TVA-SQN-TS-03-08

**SEQUOYAH NUCLEAR PLANT (SQN) - UNIT 2 - TECHNICAL  
SPECIFICATION (TS) CHANGE NO. 03-08, "REACTOR COOLANT SYSTEM  
HEATUP AND COOLDOWN CURVES"**

Proposed Technical Specification Changes (mark-up)

FIGURE 3.4-2 SEQUOYAH UNIT 2 REACTOR COOLANT SYSTEM HEATUP LIMITATIONS  
APPLICABLE UP TO 44.5 EFFY

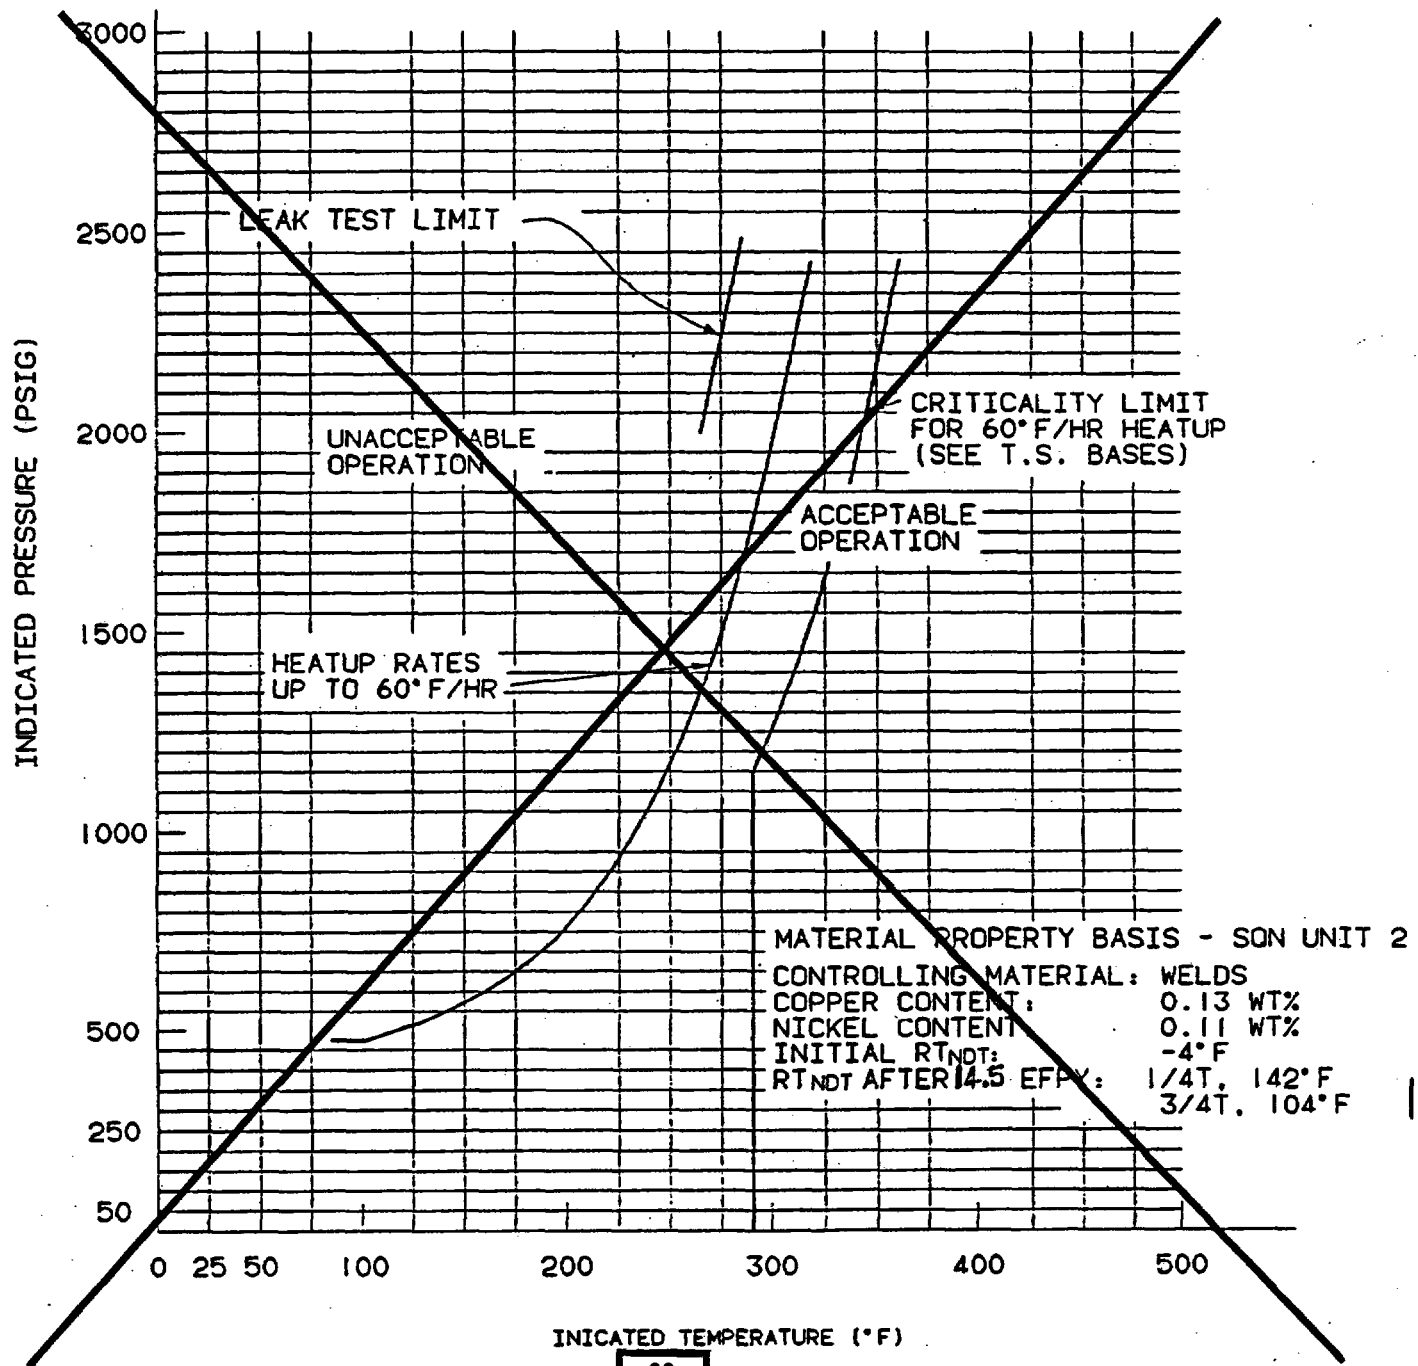
REPLACE FIGURE  
3.4-2 WITH  
ATTACHMENT 1

APPLICABLE FOR HEATUP RATES UP TO 60°F/HR  
FOR THE SERVICE PERIOD UP TO 44.5 EFFY. MARGINS OF 60 PSIG  
AND 10°F ARE INCLUDED FOR POSSIBLE INSTRUMENT ERRORS.

FIGURE 3.4-3 SEQUOYAH UNIT 2 REACTOR COOLANT SYSTEM COOLDOWN LIMITATIONS  
APPLICABLE UP TO 44.5 EFY

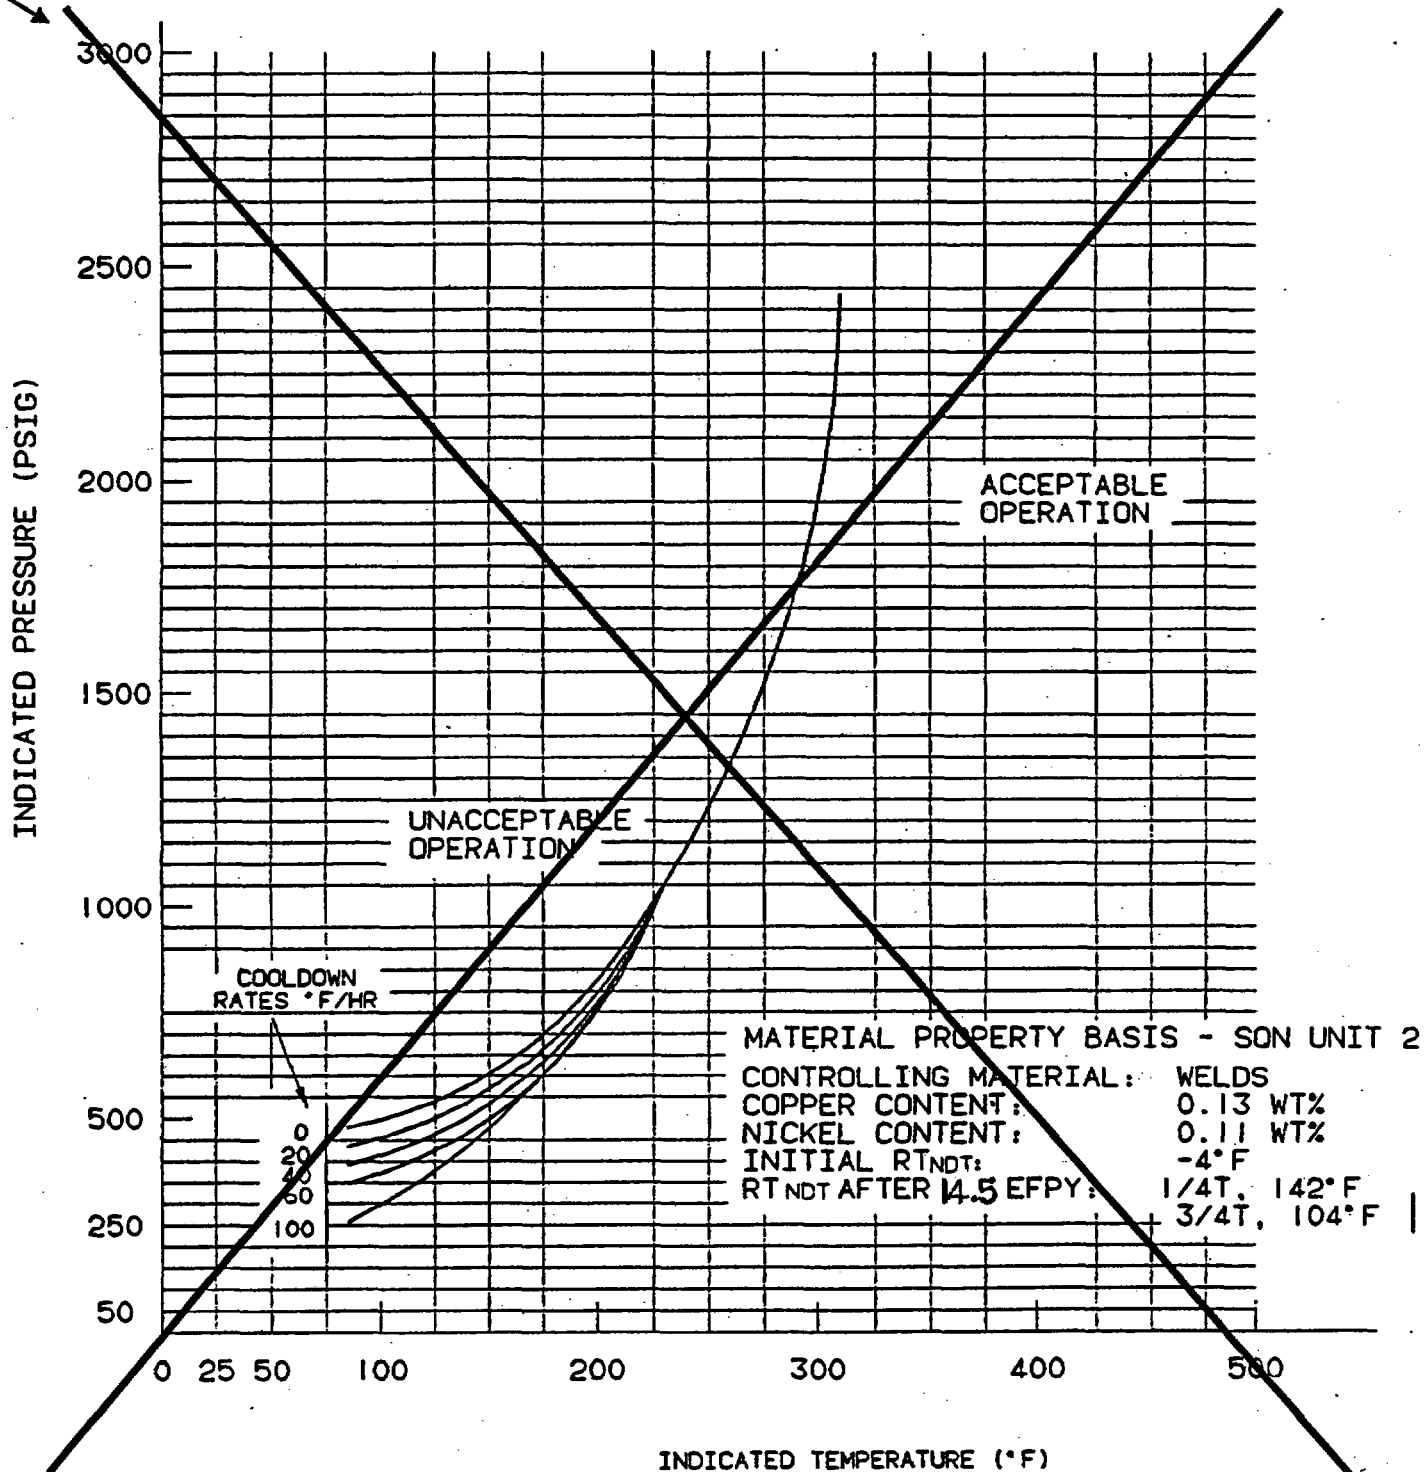
REPLACE  
FIGURE 3.4-3  
WITH ATTACHMENT 2

CURVES APPLICABLE FOR COOLDOWN RATES UP TO 100°F/HR  
FOR THE SERVICE PERIOD UP TO 44.5 EFY. MARGINS OF 60 PSIG  
AND 10°F ARE INCLUDED FOR POSSIBLE INSTRUMENT ERRORS.

FIGURE 3.4-4

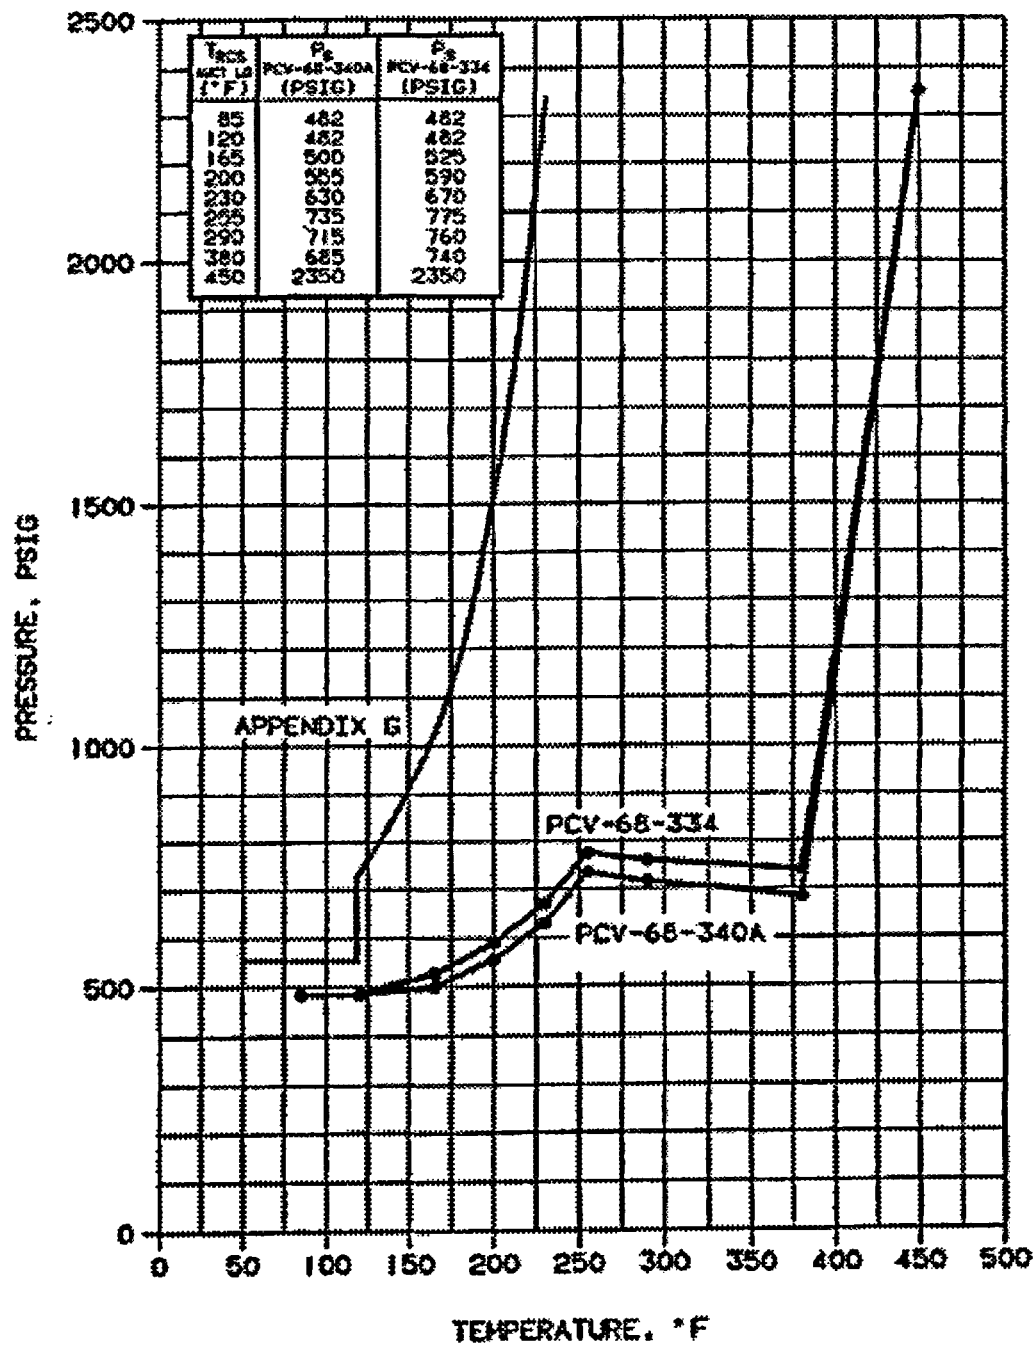
In addition, the proposed change includes a revision to TS 3/4.4.12 and the associated Figure 3.4-4 that provides low temperature overpressure protection (LTOP) setpoints. The proposed revision extends the applicability of the setpoints to 32 EFPYs and revises the Appendix G limit to reflect the updated 32 EFPY cooldown limit.

PORV NOMINAL LIFT SETTINGS - APPLICABLE UP TO 44.5 EFPPY
